**“RE-BID PEDESTRIAN BRIDGE CONSTRUCTION AT COUNTY PARK NORTH,
TOWNSHIP OF UPPER”**

Re: **RE-BID OF PEDESTRIAN BRIDGE CONSTRUCTION
AT COUNTY PARK – NORTH
(CAMERON PARK)
TOWNSHIP OF UPPER
CAPE MAY COUNTY, NJ
ADDENDUM NO. 1**

ADDENDUM NO. 1

PILE ENCASEMENT DETAIL

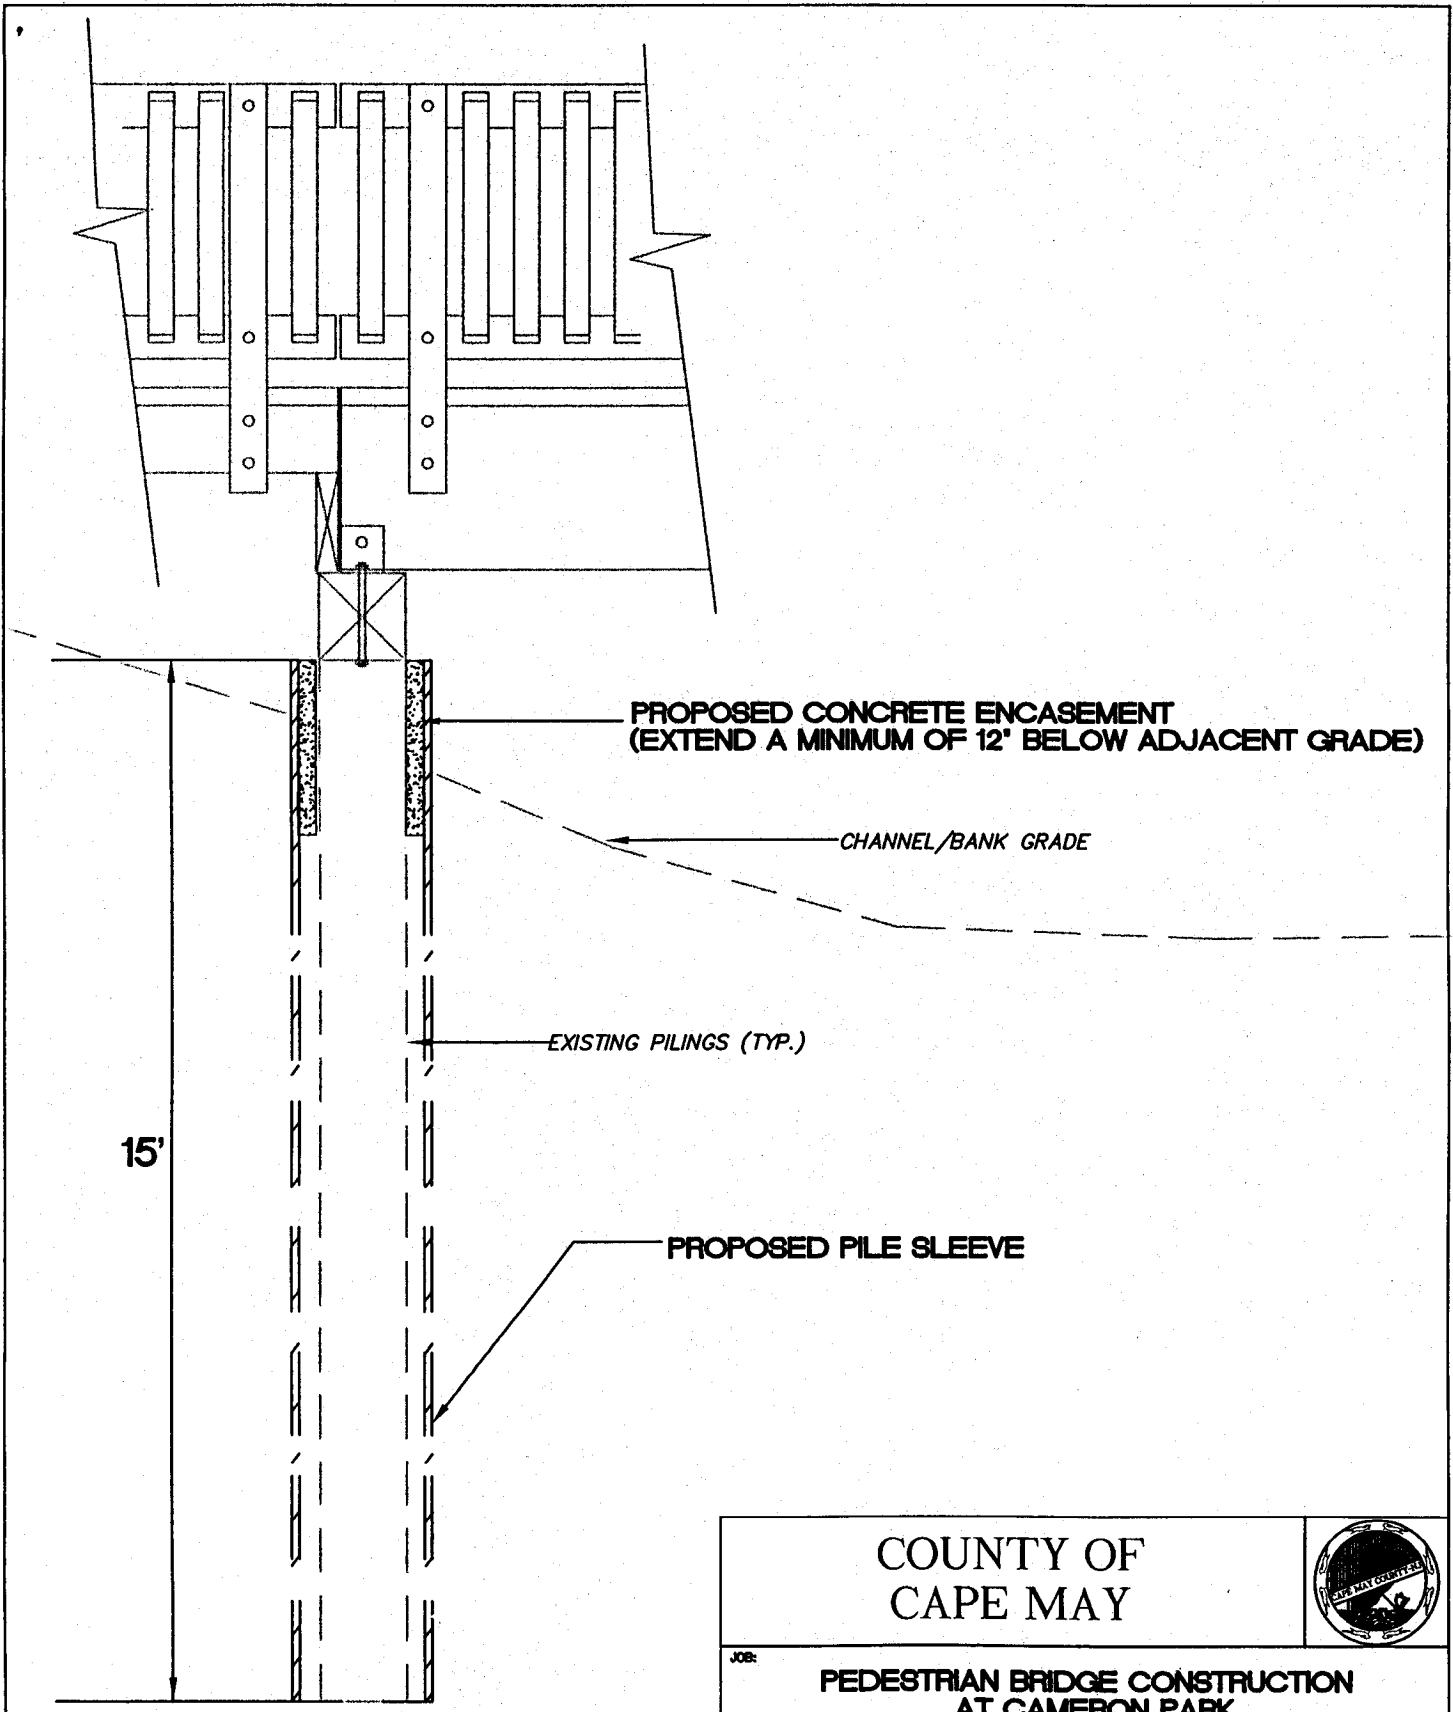
Attached hereto is a Sketch (Sheet 1 of 1) containing "PILE ENCASEMENT DETAIL". This detail shall become part of the construction plans for this contract.
